**Appendix 6.2: ABIA Master Plan
Safety Assessment Areas
SRM Panel Review**

Table A6.2-1: ABIA Master Plan Safety Assessment Areas SRM Panel Review

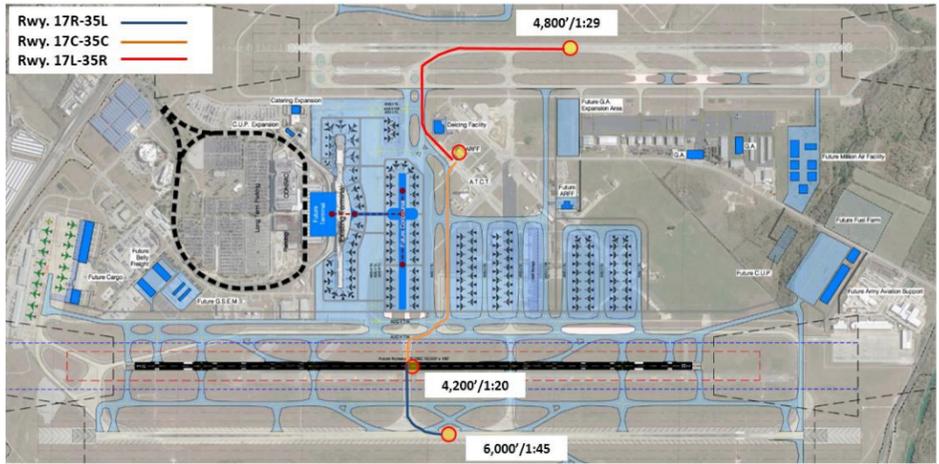
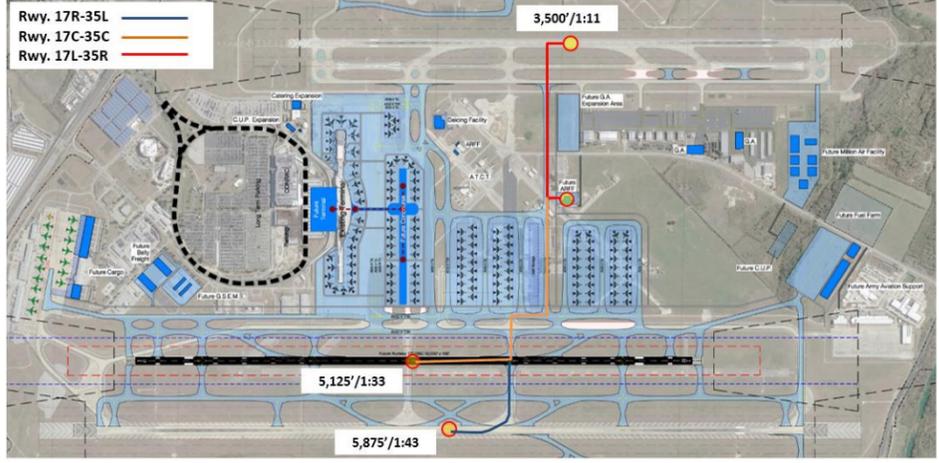
6.	Runway and Taxiway Geometry	Mid-field taxiway routes and constraints	<p>Proposed taxiway layout and flows do not provide the ability to get from one side of the airfield to the other. From an ATC perspective, we don't always put GA aircraft on the east Runway. For safety and efficiency, aircraft are often sequenced to the west runway(s) and need to spend more time taxiing to the east side. The new configuration does not allow for easy access.</p> <p>LAYOUTS at Oklahoma City, Louisville, Orlando, Los Angeles, Phoenix, Portland, Salt Lake City, and Dallas-Fort Worth. All have at least two, often parallel, taxiways that go from one side of the airfield to the other without passing through parking areas or the terminal ramp. With the future concourse moving south and eliminating the present-day mid-field crossing taxiways, additional taxiways need to be built. My first thought would be at "J" but that runs through the south terminal area. My next thought would be crossing at "N". In both locations, the use of bridges or tunnels may be required to access those parts of the airport served by ARFF, Air Traffic Control, and others.</p> <p>Option 1</p> <ul style="list-style-type: none"> This option provides two non-parallel and separate ADG-V crossfield taxiways. First taxiway is south of the proposed remote concourse and takes a circuitous route to avoid the existing ATCT, ARFF and deicing facilities. Second taxiway is located south of the South Terminal and is a straight-line connection between the runways. This will have no impact on the existing South Terminal and GA/FBO facilities. Requires the RON apron to move further south. Need to depress Emma Browning Ave. under the single taxiway bridge. <p>Option 2:</p> <ul style="list-style-type: none"> This option provides dual parallel ADG-V crossfield taxiways. They are located between the existing South Terminal and GA/FBO facilities. Preliminary indications are they will not affect these facilities. Requires the RON apron to move further south. Need to depress Emma Browning Ave. under the dual taxiway bridge. <p>Option 3</p> <ul style="list-style-type: none"> This option provides two ADG-V crossfield taxiways. The north crossfield taxiway is located south of the first remote concourse. The south crossfield taxiway is located between the South Terminal and GA/FBO facilities. Requires the RON apron to move further south. Need to depress Emma Browning Ave. under the single taxiway bridge. 	<p>Providing a dual crossfield ADG-V taxiway at Taxiway 'N' will require demolition of various GA/FBO hangars and apron. It will also eliminate the 20-acre GA expansion area to the north. Providing a dual crossfield ADG-V taxiway at Taxiway 'J' will impact the existing South Terminal and aircraft ramp area. A dual ADG-V taxiway between the runways (east-west direction) would need to be located between Taxiway 'N' and the existing ATCT. This area will have an impact on the South Terminal and require these airlines to relocate to the new BJT/concourse facility. This dual parallel ADG-V taxiway should be located such that it is compatible with the next mid-field concourse and long-term (post 20-yr.) terminal expansion. The updated airfield layout has taken the future remote concourses into consideration when locating the crossfield taxiway. It is compatible with the long-term concourse locations.</p> <p>Option 1</p>  <p>Option 2</p> 	<p>See assessment area #5 for proposed resolution.</p> <p>Action: Add an additional crossfield taxiway option.</p> <p>Resolution: See Options 1, 2, and a new Option 3 drawing in the column to the left and the Exhibit/Drawing within the SRMP Report as discussed during the SRM Panel Session.</p>
